**UNITED STATES ENVIRONMENTAL PROTECTION AGENCY**

**Re: Request for Information  
Docket No. CWA-IR-15-010  
EPA Reconnaissance Inspection September 18, 2014  
U.T.A Mesivta of Kiryas Joel, Berdicheve Road, Kiryas Joel NY  
SPDES Permit Identification Number: NYR10X832**

United States Environmental Protection Agency  
Washington, D.C. 20460  
**Water Compliance Inspection Report**

## **SUMMARY OF FINDINGS/COMMENTS**

DSCN2321

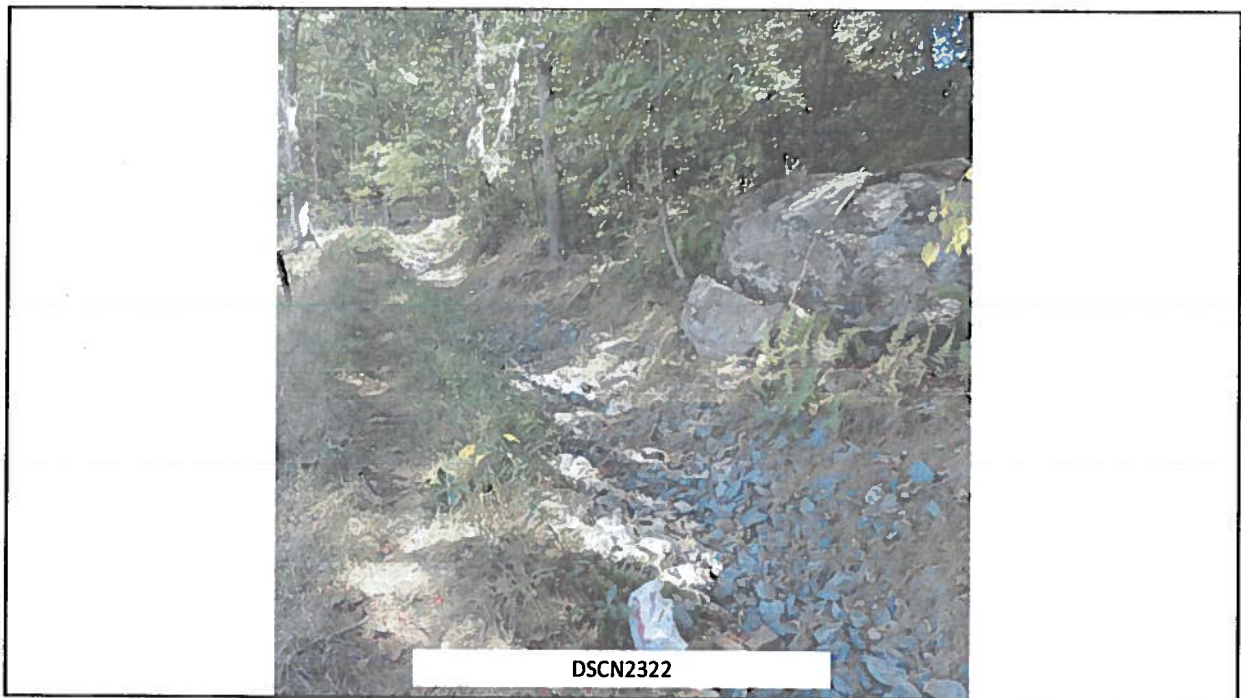
- a. As shown in photos 320 and 321 the slopes at the lower site were not stabilized and there were not stormwater Best Management Practices ("BMPs") in place at portions of the site near the stream. The Erosion Control Plan for the Lower site specifies that there will be silt fencing along the southwestern boundary of the site (See Erosion Control Plan Attachment 2)

- d. Section VI, Erosion Control, of the SWPPP indicates that mulching will be installed at the site. When the site was inspected in April 2014 there was mulch over much of the site. During this September 2014 inspection as shown in photographs 318 to 321, 327, and 328 do not show mulching being utilized on unstabilized areas of this site. Additionally the SWPPP specifies that temporary seeding will be utilized in all areas that are expected to remain disturbed for a period of 14 days.

DSCN2322

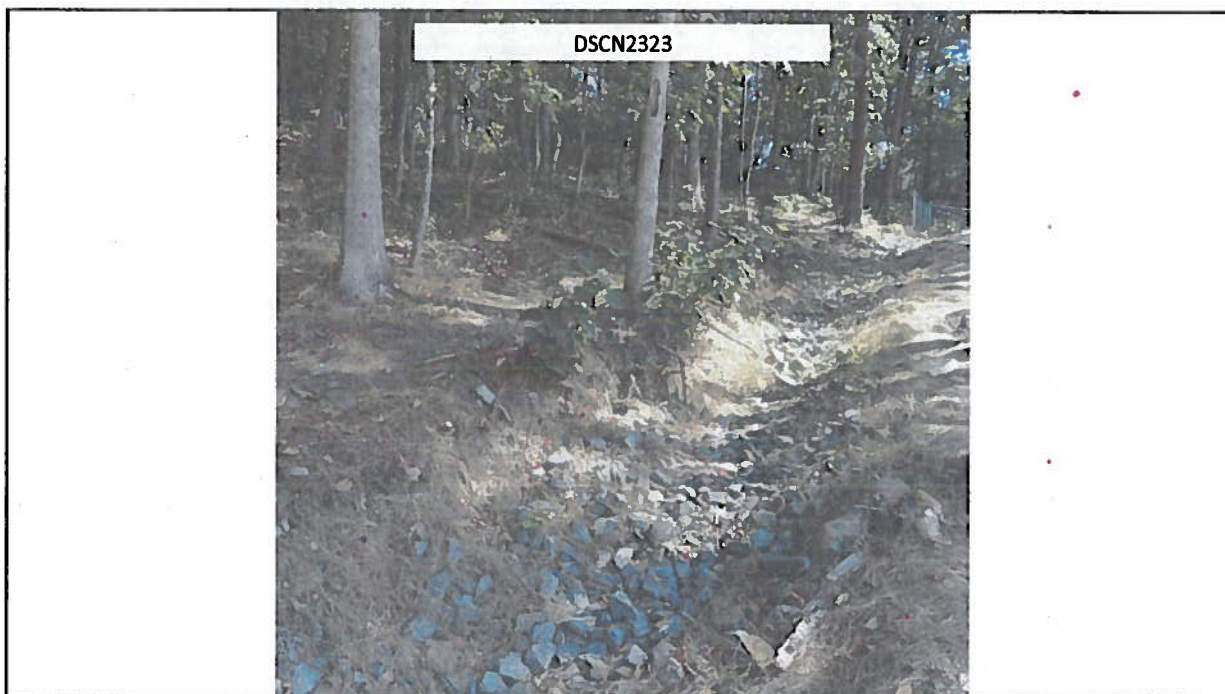
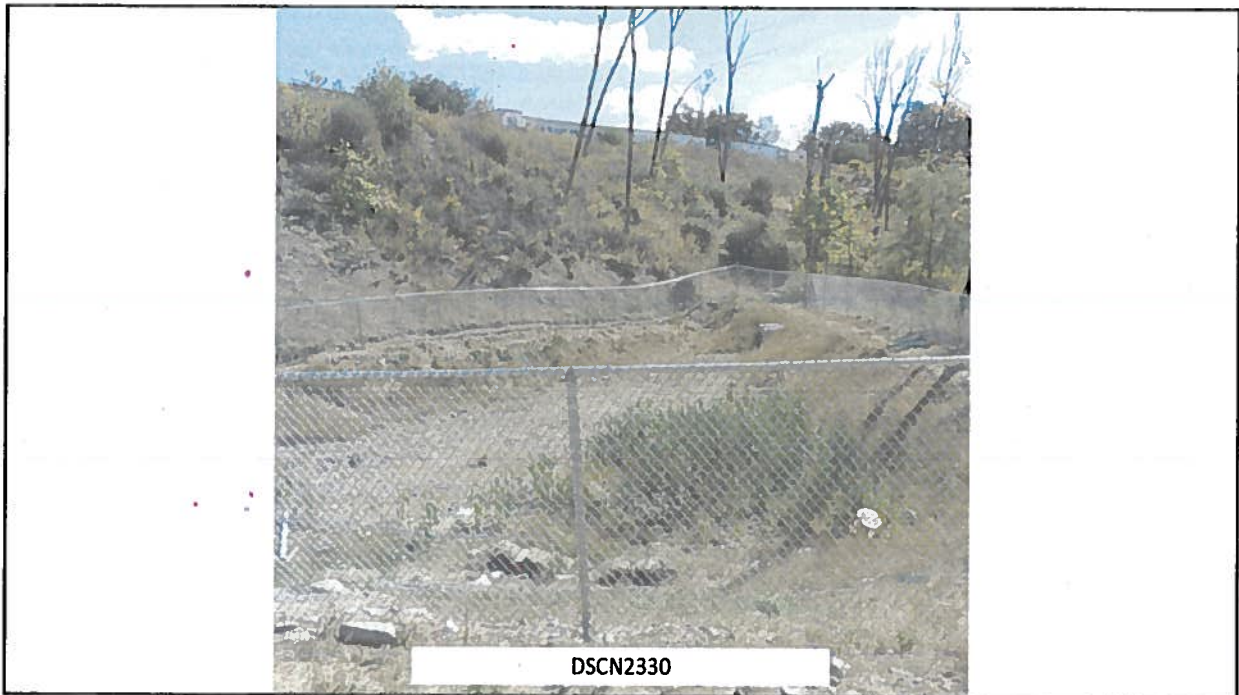
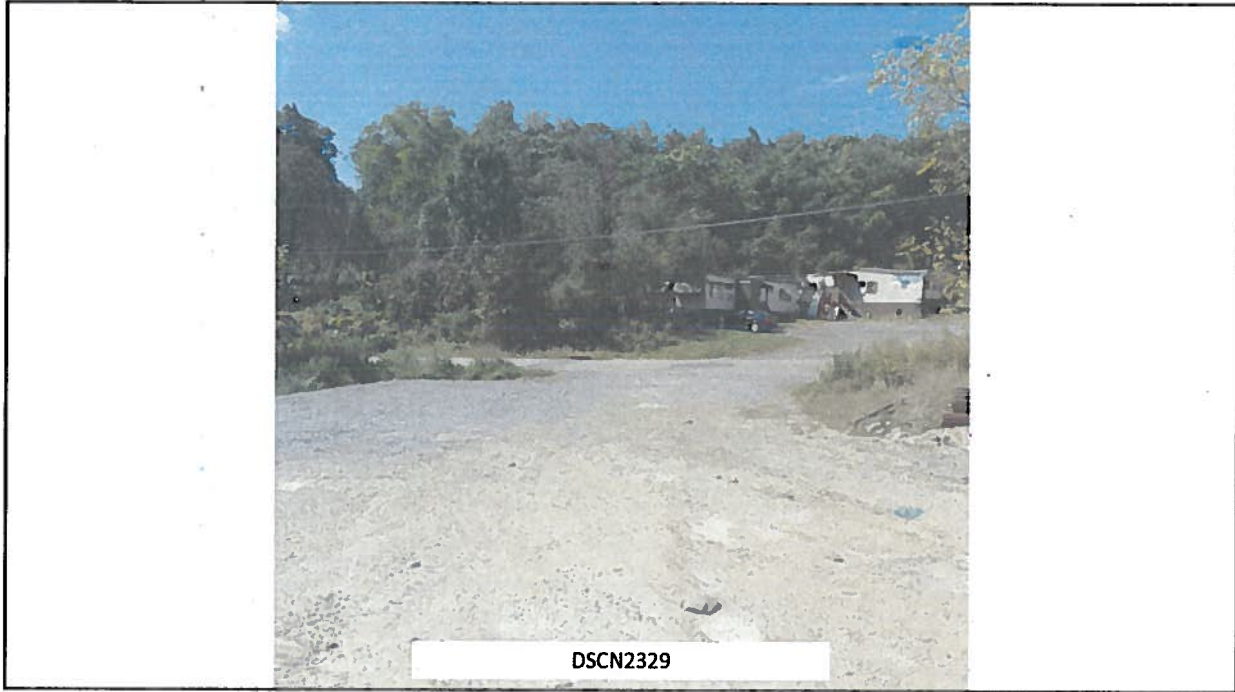
- c. As shown in photo No. 326, the flow path near the upstream portion of the site at the headwall where the stream flows into an underground conduit needs to be stabilized and additional Stormwater Best Management Practices in this area should be employed.

DSCN2332

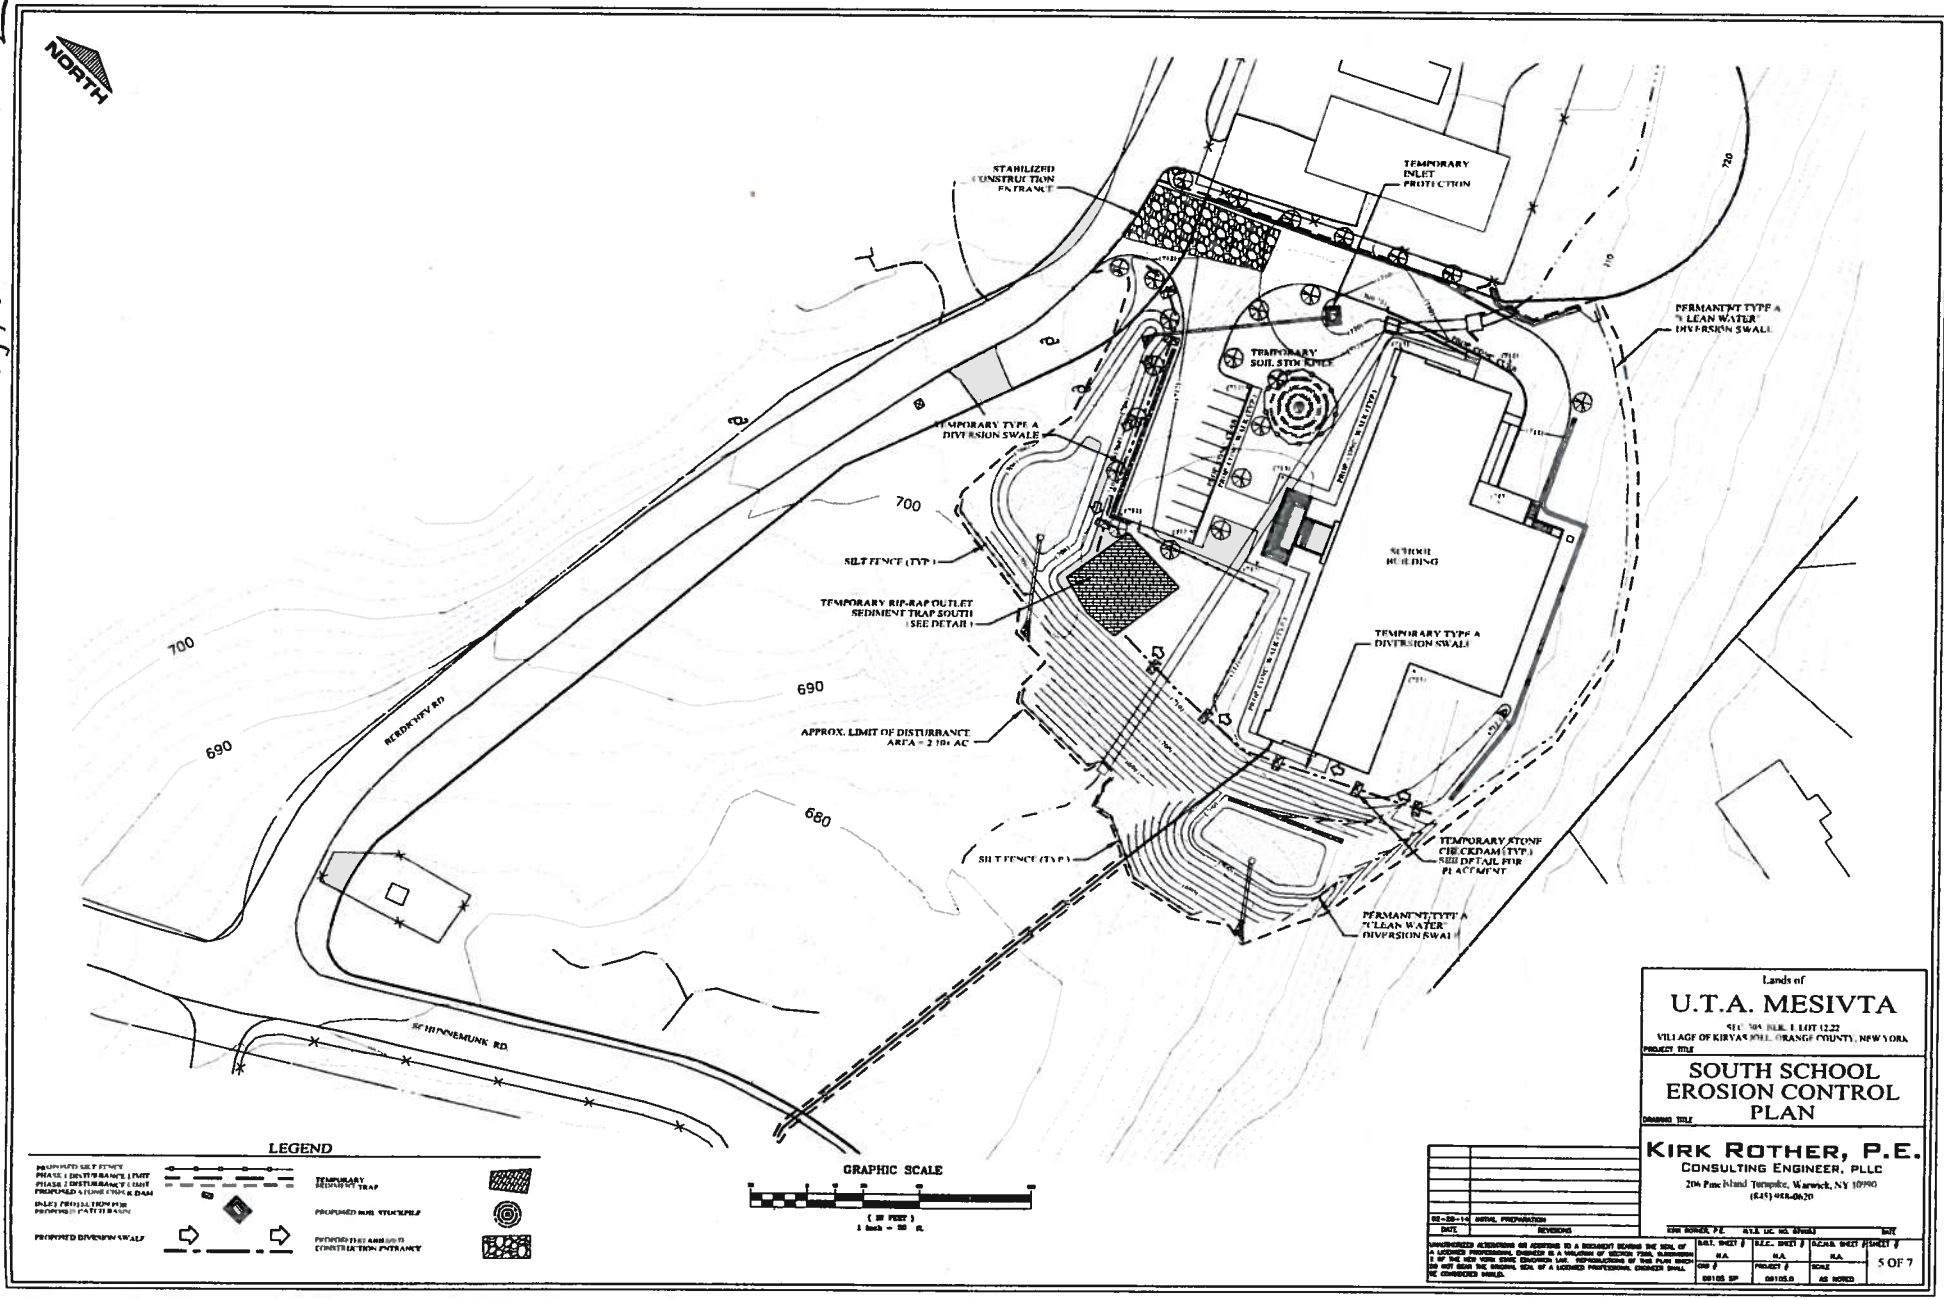
- a. As shown in photos 330 and 331 there were bare spots in the vegetative cover. Please ensure that the proper vegetative cover (80% coverage) is achieved on the site – some bare spots were seen on site.
- b. As shown in the photo 332 there was construction debris and waste material not properly stored. This material should be stored in a covered dumpster and properly disposed of. As described above the SWPPP does not contain the measures for waste storage and pollution prevention as required by Parts III.B.1.b and III.b.1.j of the CGP.
- c. The Site Plan for the Upper Site (Attachment 5) specifies that there will be two bio-retention areas (No. 1 and 2) with filter bed areas of 920 and 2,465 sq. ft respectively. Neither of these bio-retention areas was detected during this inspection.

South School  
SITE  
PLAN

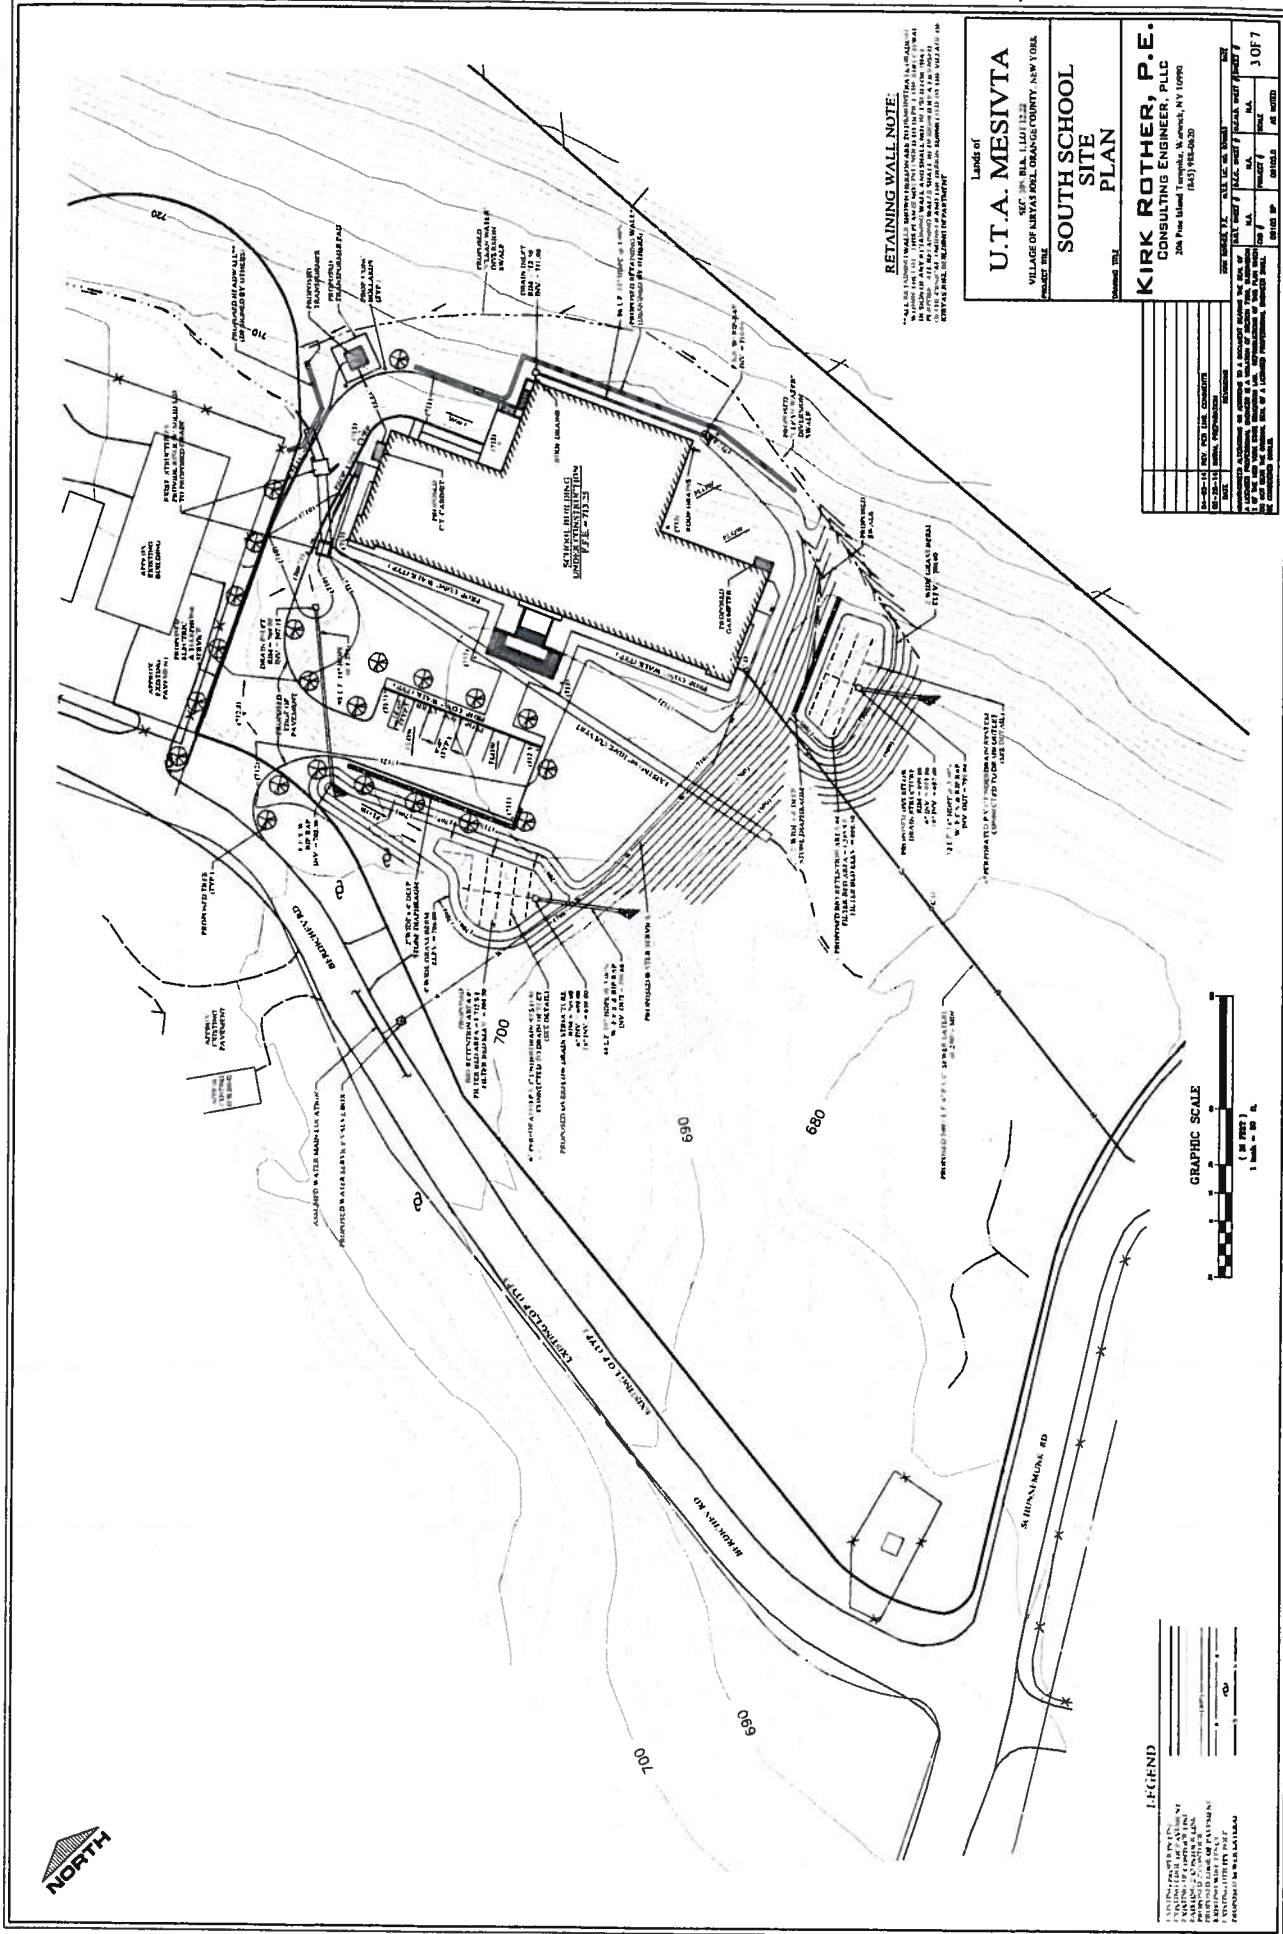
- b. As shown in photo (318) the construction entrance at the lower site, especially the more downhill (southern) entrance closer to Schunnemunk Road site does not have the required 6" thickness of 1.5" crushed stone over the entire 50' length of the construction entrance as required in the SWPPP's construction details. See below. Additionally, filter cloth was not seen below the stone as specified in the construction details. The construction entrance has not been properly maintained and/or installed in accordance with the SWPPP and the sites's Erosion Control Plan (See Stabilized Construction Entrance specifications from the U.T.A Mesivta's erosion control plan below). The Stabilized Construction Entrance is in need of maintenance and also does not conform with Section 5A of the NYS Standards and Specifications for Erosion and Sediment Control. Furthermore as shown in Attachments 2 and 4 this Southern Entrance at the Lower Site is not included in the

Erosion Control Plan or Site Plan as required by Part III.B.1 of the CGP, only the northern entrance to the Lower Site is shown on these drawings.

- f. The Site Plan for the Lower Site (Attachment 4) specifies that there will be two bio-retention areas (No. 3 and 4) with filter bed areas of 1,715 and 1,585 sq. ft respectively. Neither of these bio-retention areas was detected during the inspection. Section VII, Construction Sequence, of the SWPPP sates that the bio-retention areas will be shaped and overflow structures installed.
